BOARD ACTION REPORT – APPEALABLE ITEM

Project Name: AutoNation Delray
Project Location: 1311 Linton Boulevard
Request: Class V Site Plan, Landscape Plan, and Architectural Elevations.

Board: Site Plan Review and Appearance Board
Meeting Date: February 22, 2017

AGENDA ITEM: AutoNation Delray Beach (File #2016-268) – Class V Site Plan, Landscape Plan and Architectural Elevations associated with construction of a 105,400 square foot automobile dealership at 1311 West Linton Boulevard.

LANDSCAPE PLAN
SHEET NUMBER
L-3A

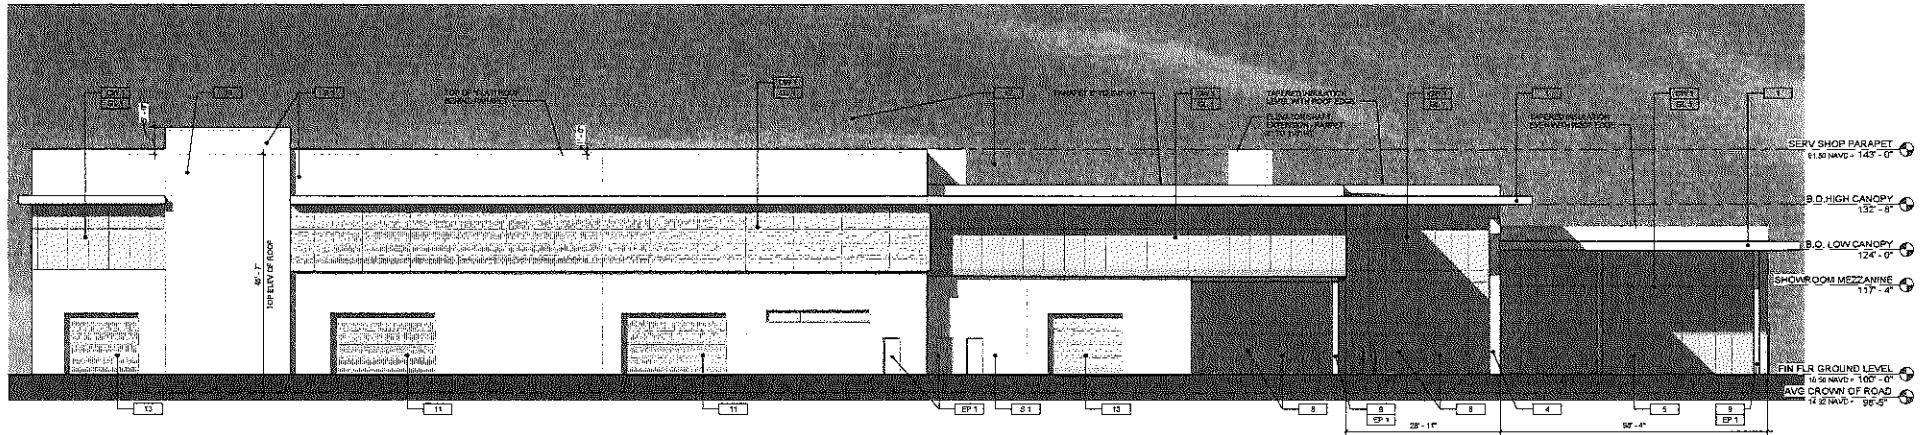
Per LDR Section 4.6.16(H)(3)(i), landscape islands which contain a minimum of 135 square feet of planting area, with a minimum dimension of 9 feet, exclusive of the required curb, shall be placed at intervals of no less than one landscaped island for every 13 standard parking spaces. One shade tree shall be planted in every island with a minimum of 75 square feet of shrubs and groundcovers. Tree specifications shall adhere to those listed in Section 4.6.16(E)(5) and 4.6.16(E)(6). Where approval for the use of compact parking has been approved, islands may be placed at intervals of no less than one 1 island for every 15 compact parking spaces. This landscape island is required for the display parking spaces along Linton Boulevard, where 27

and 14 parking spaces are provided in a row without the required landscape island. A condition of approval is attached that the plans be revised to provide the required interval of landscape islands and landscaping.

Move approval of the landscape plan for **AutoNation Delray Beach**, by adopting the findings of fact and law contained in the staff report, and finding that the request is consistent with Section 4.6.16 of the Land Development Regulations, subject to the condition that the plans be revised to provide the required interval of landscape islands and landscaping prior to certification of the site plan.
